RE: SUBMISSIONS ON PROPOSED GAS TO POWER POWERSHIP PROJECT AT THE PORT OF NGQURA AND COEGA SEZ, NELSON MANDELA BAY METROPOLITAN MUNICIPALITY, EASTERN CAPE (REF 14/12/16/3/3/2/2005)

These submissions are made by the Biodiversity Law Centre and Green Connection, supported by the Centre for Environmental Rights, in response to the 2022 Draft EIA report (“DEIAr”) published for comment by Karpowership SA (Pty) Ltd for the Gas to Power Via Powerships Project for the port of Ngqura.

Figure 6-13: Map of the FEPA Rivers and Wetland in relation to the proposed development, from the NFEPA dataset.

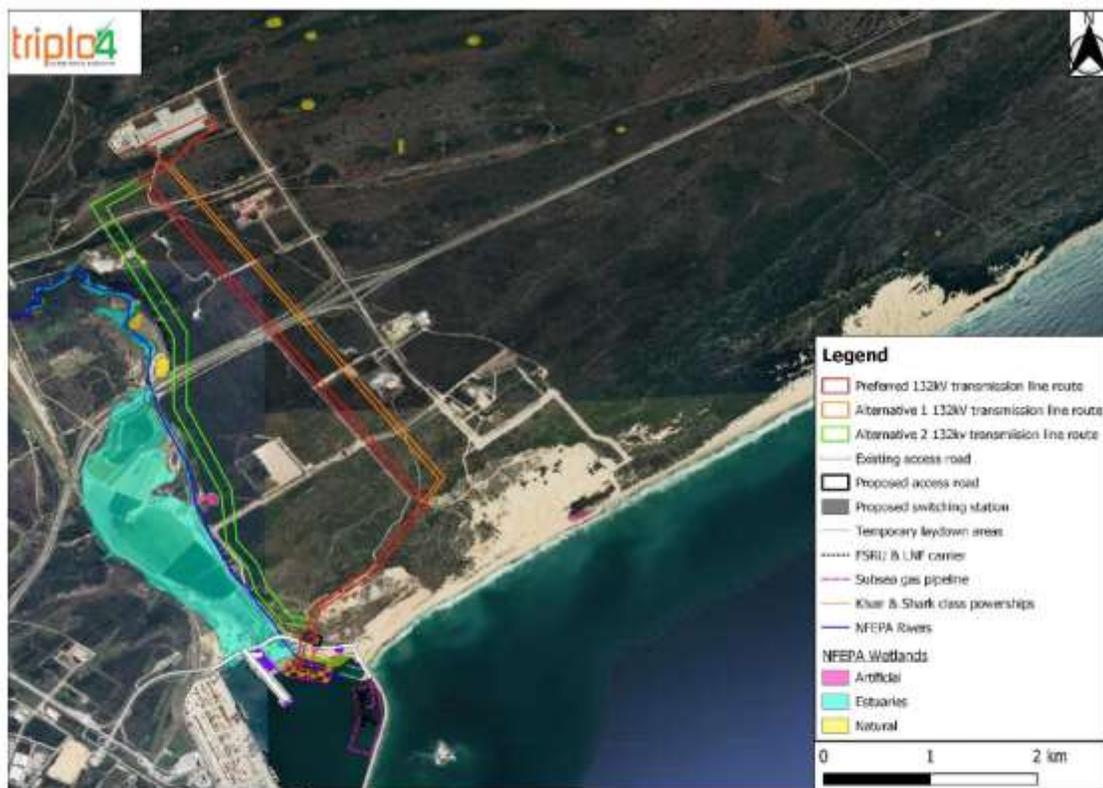
River will run directly into the Project—and will have to face increased water temperatures and elevated noise levels. This would be true for, among other species, the estuarine-dependent dusky kob, which is endangered, and which the DIEAR admits “is in a critical state and is important to the commercial line fishing industry.”¹²⁹

The Project tries to minimize the seriousness of the Project’s location by stating that the Coega estuary system is highly degraded already and that it is ranked as having low to medium biodiversity importance.¹³⁰ But as stated above, the DEIAr omits the fact that national biodiversity guidance instructs planners that “further ecological deterioration must be avoided” in Ecological Support Areas like the Project site—and that these sites (including the Project site) are biodiversity priority areas necessary to achieve South Africa’s biodiversity goals. In addition, this characterization of the site as already degraded
